#10-06-01-008G: Engine Oil Consumption on Aluminum Block/Iron Block Engines with Active Fuel Management (AFM) (Install AFM Oil Deflector and Clean Carbon from Cylinder and/or Install Updated Valve Cover) - (Jan 3, 2013)

Models: 2007-2011 Cadillac Escalade Models

This bulletin is being revised to update the Warranty Information. Please discard Corporate Bulletin Number 10-06-01-008F (Section 06 – Engine/Propulsion System).

- 1) Old Design
- 2) New Design

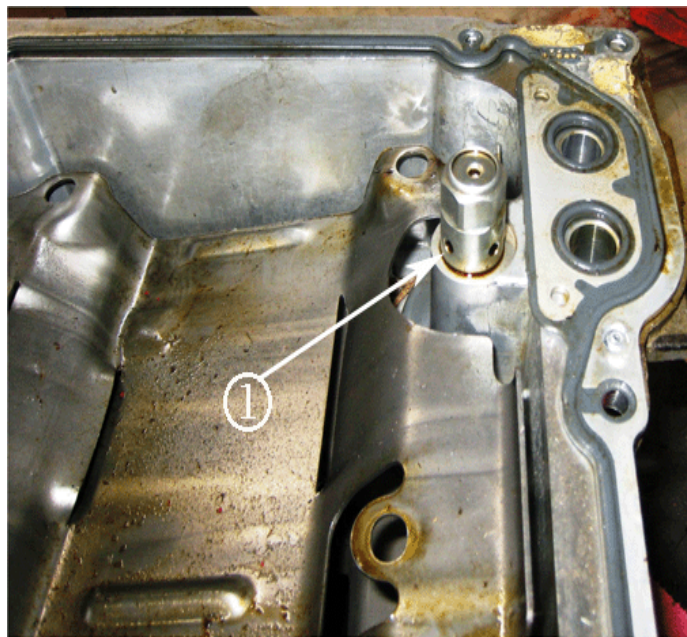
Aluminum or Cast Iron Block - Oil in Intake Manifold - Install Updated Valve Cover on All Models Built Prior to February 1, 2011

PCV pullover or an overactive lifter can cause oil to be pulled through the PCV system even at low vehicle mileage. A correctly functioning PCV system will only leave a film of oil in the intake manifold. Inspect the intake manifold to see if there is any oil puddling in the bottom. If there is you will need to replace the left valve cover. Two new left rocker arm covers have been released for trucks and vans. Technicians should replace the left rocker arm cover with GM P/N 12570427 for 2007-2008 or GM P/N 12642655 for 2009-2011. Refer to the Parts Information below for the Camaro. This rocker arm cover has a relocated PCV drain hole that prevents oil from entering the intake manifold. Refer to Valve Rocker Arm Cover Replacement - Left Side in SI.

Note: These rocker covers are for specific years. The PCV orifice is different for each. The correct

cover must be used or an SES light may set.

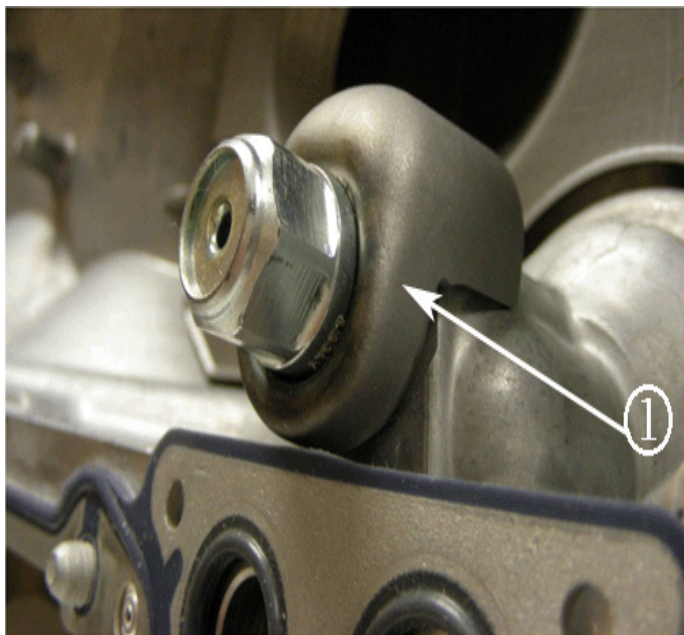
4. Remove the AFM valve (1).

5. Install the new shield (1), GM P/N 12639759, and tighten the AFM valve to the oil pan to 28 N·m (20 lb ft).
